**Enclosure 1
Response to
Maryland State Highway Administration Comments on
Traffic Impact Study, 2011**

**RESPONSE TO MARCH 17, 2011 SHA COMMENTS ON
TRAFFIC IMPACT STUDY DATED FEBRUARY 2, 2011**

June 17, 2011

**Traffic Impact Study at the
Calvert Cliffs Nuclear Power Plant
Draft Final Report**

Figure 9 – Peak Hour Traffic Volumes During Construction

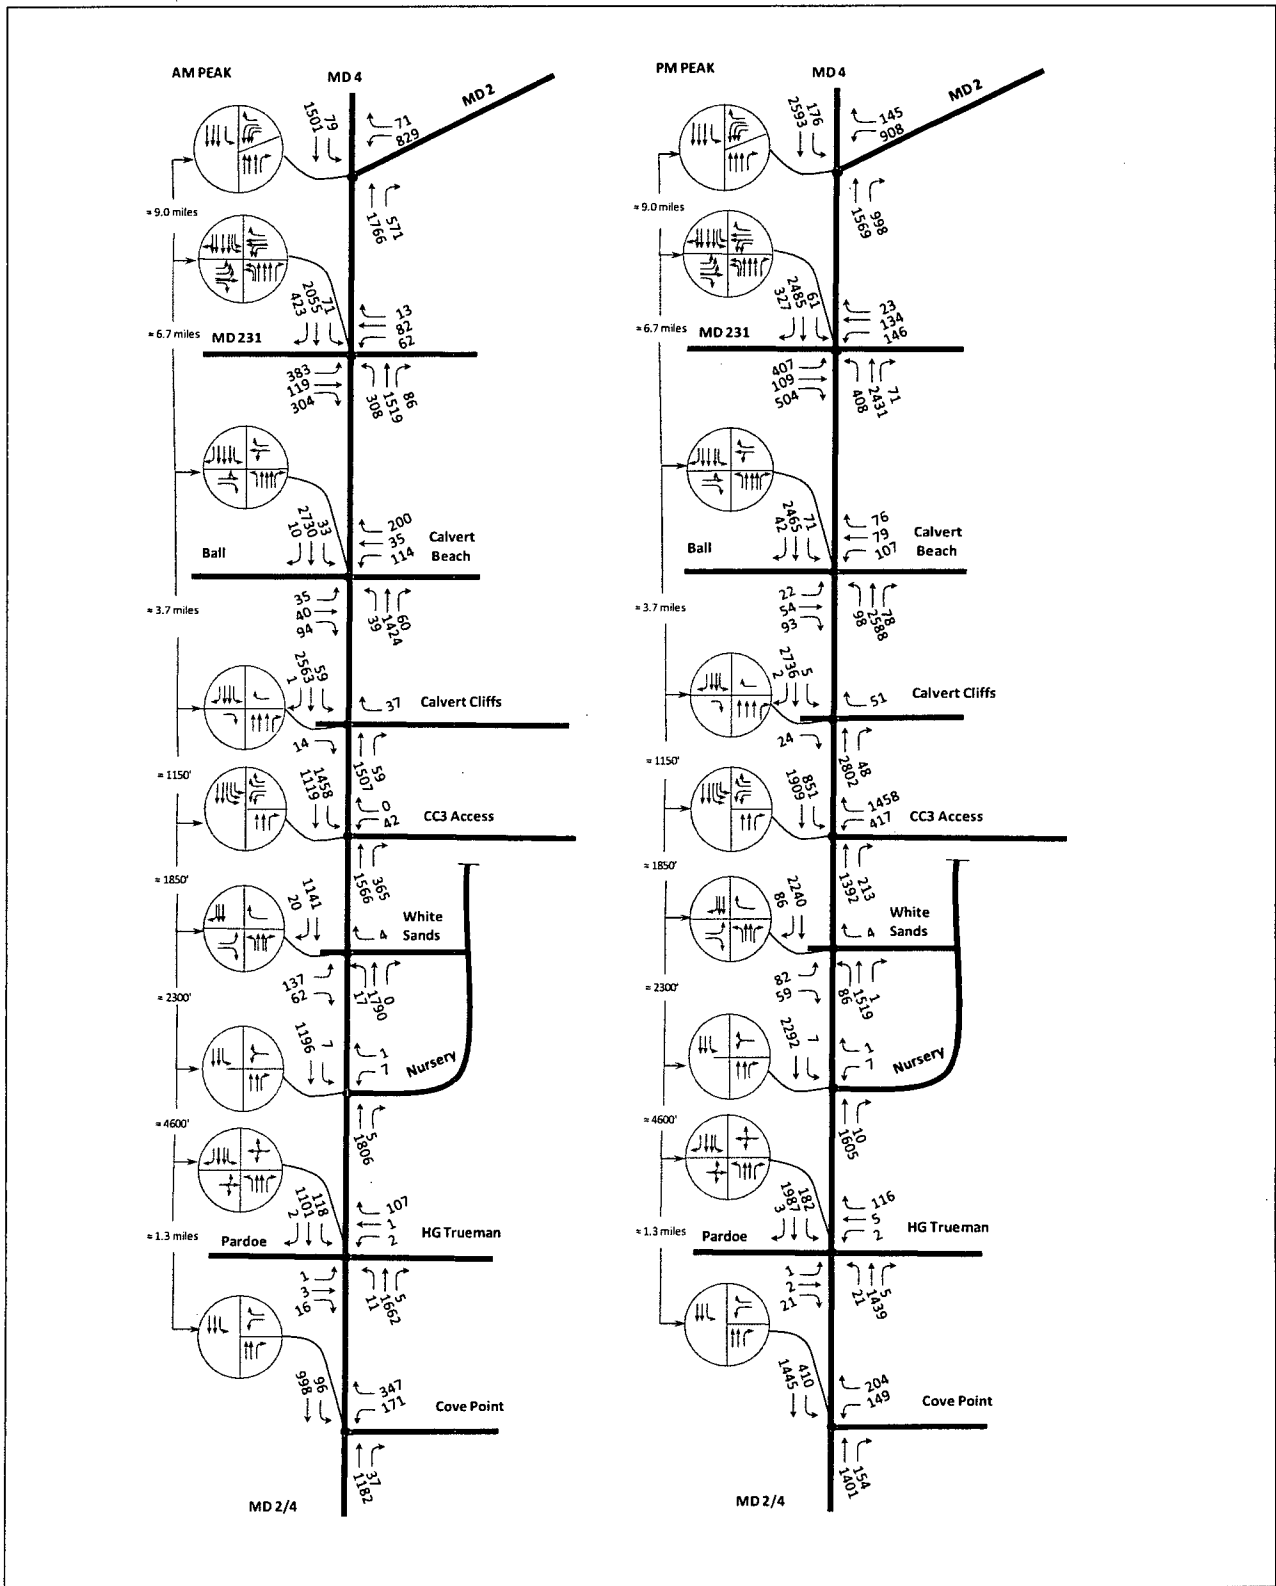
- 1) Figure 9 Illustrates a left turn lane from Calvert Cliffs Parkway to southbound MD 2-4. The left turn movement is to be eliminated while temporary access is in operation. In addition, the proposed traffic control at the intersection of MD 2-4 with Calvert Cliffs Parkway must be clarified.

- 3) The lane configuration along MD 2-4 at the proposed temporary site access is not consistent throughout the analysis.

Response: Figure 9 has been revised accordingly. During construction, the signal at the MD 2-4/Calvert Cliffs Parkway intersection will continue to operate, but the WB phase will be eliminated. The text and figures have been revised to explicitly indicate this.

Response: The final configuration on northbound MD 2-4 at the proposed temporary site access is 2 thru and 1 right turn lane. Figures 9 and 10 have been revised accordingly.

Figure 14 – MD 2/MD 4 and MD 231 – Mitigation Measures – 2016 Conditions – Option 1

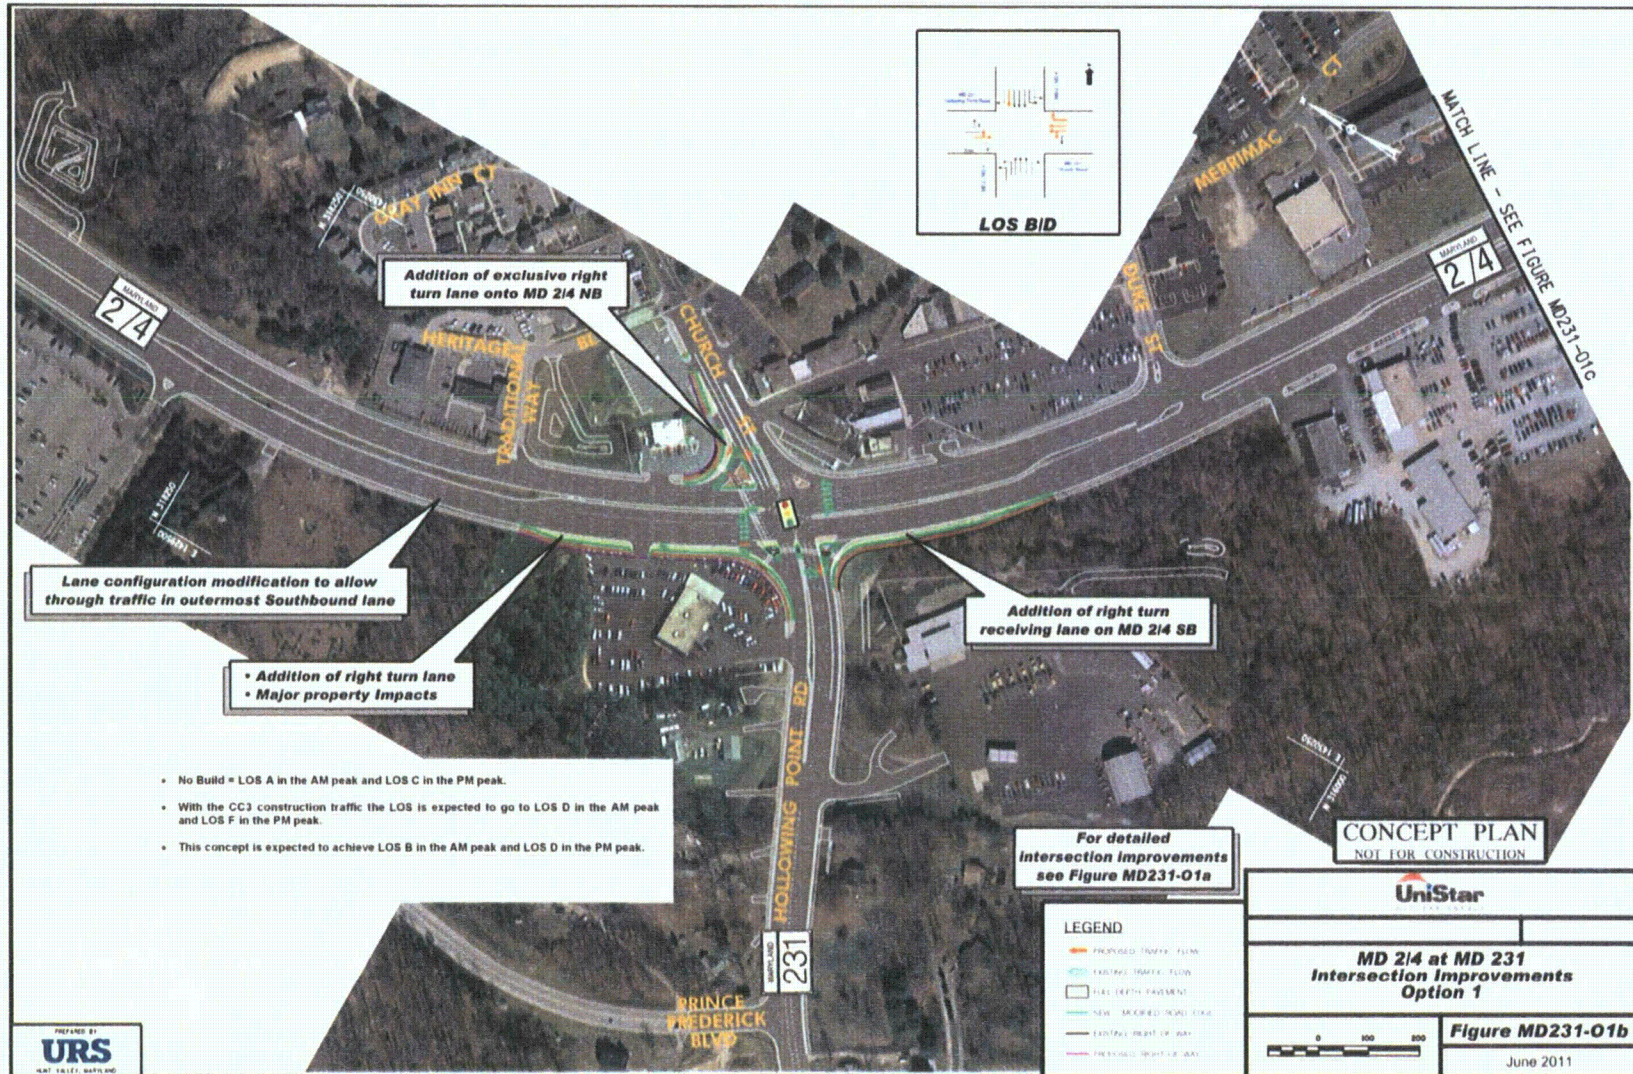
- 11) The existing third lane along southbound MD 2-4 at MD 231 becomes a lane drop at the next intersection 1500ft to the south (Old Field Lane/Sherry Lane). The concept plans must clearly indicate how two lanes would be dropped within 1500 ft., or if one of the lanes would be extended beyond the adjacent intersection.

Response: The proposed configuration extends the third lane beyond the adjacent intersection for Option 1 only. The drawings related to the intersection of MD2-4 at MD 231 (Option 1) have been modified to include the adjacent intersection of MD 2-4/Old Field Lane/Sherry Lane. The revised figures depicting the proposed design are included in the updated Traffic Study.
